Appln No. 10/581,782
Amdt date August 6, 2008
Reply to Office action of April 21, 2008

REMARKS/ARGUMENTS

Figure 12

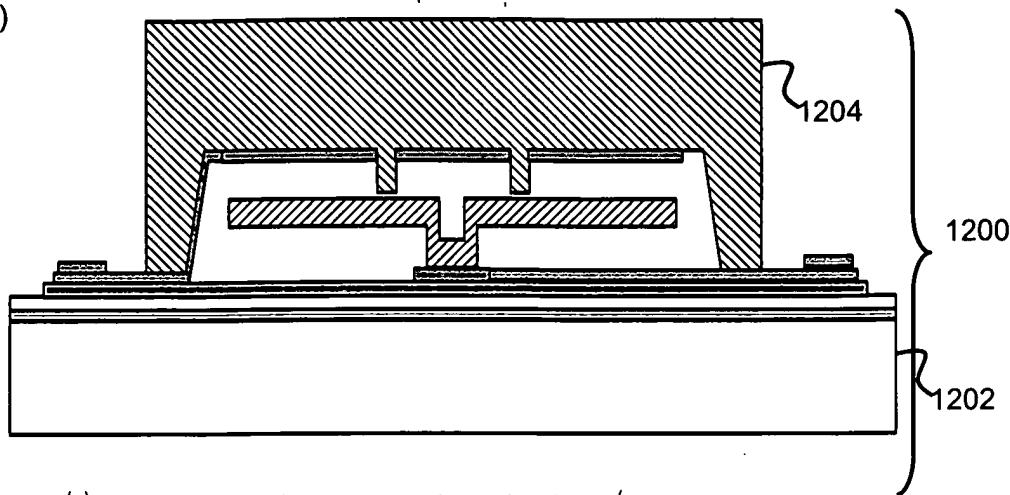
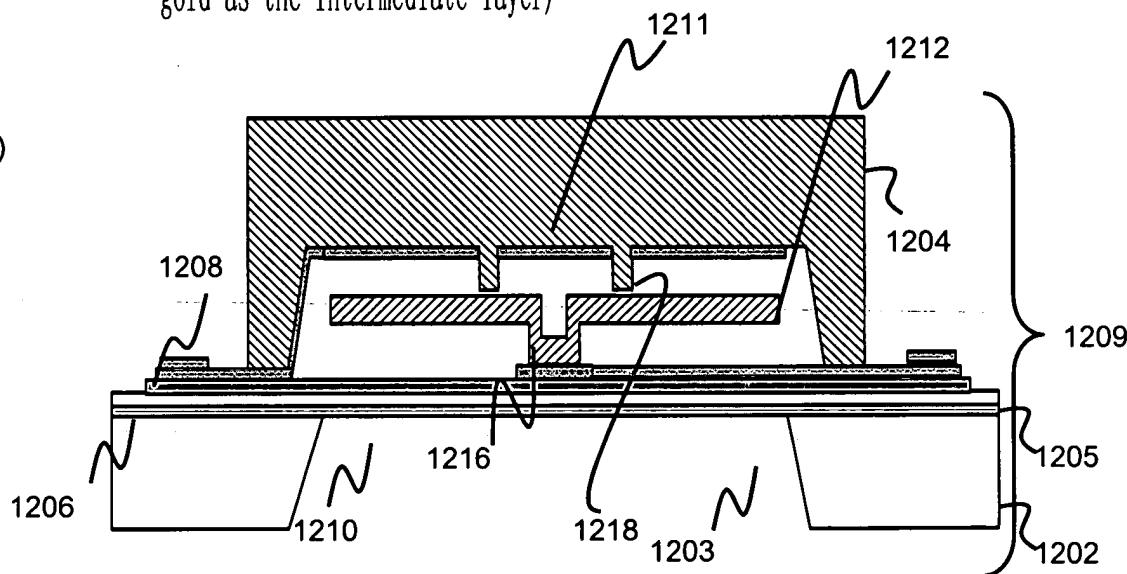
The drawings are objected to because "the key for FIG. 12 indicates solid black as being both the nitride and the metal materials," and that the "support structure" of claim 1 & "contact member" of claim 2" must be shown. A replacement drawing for FIG. 12 correcting the key is enclosed.

The drawings are also objected to on the grounds that the reference characters 102 and 1210, have both been used to designate the diaphragm.

The attached annotated sheet of drawings is a includes changes to FIG. 12. The attached replacement drawing of FIG. 12 replaces the original informal sheet including FIG. 12.

With respect to lack of illustration of "support structure" of claim 1 and "contact member" of claim 2, Applicant respectfully submits that those features have been identified in the text and drawings. For example, in FIG. 12, reference 1216 has been described in the sentence bridging pages 10 and 11 as the "middle plate or cantilever 1212 is a free-standing structure supported only at the center by a post 1216.". Furthermore, reference 1218 has been described on page 11, first paragraph as "beyond a pre-determined threshold, the boss ring structure 1218 on the glass die or device base 1204 will come into contact with the middle plate or cantilever 1212 and cause it to deflect.".

Applicant respectfully submits that it is permissible to use different reference characters to designate different exemplary embodiments of the diaphragm. It is clear from the description, that the structures shown in FIG. 1 and FIG. 12 are different embodiments, and therefore it is appropriate to use different reference characters for the two different embodiments.

Therefore, in FIG. 12(b), the diaphragm 1210 is at the "bottom" of the drawing, and has been created by the backside wet etch as described. On the other hand, the structure 1204 at the "top" is the device base in this embodiment. As a result, the specification enables the invention, as claimed by claims 3, 4 and 13.
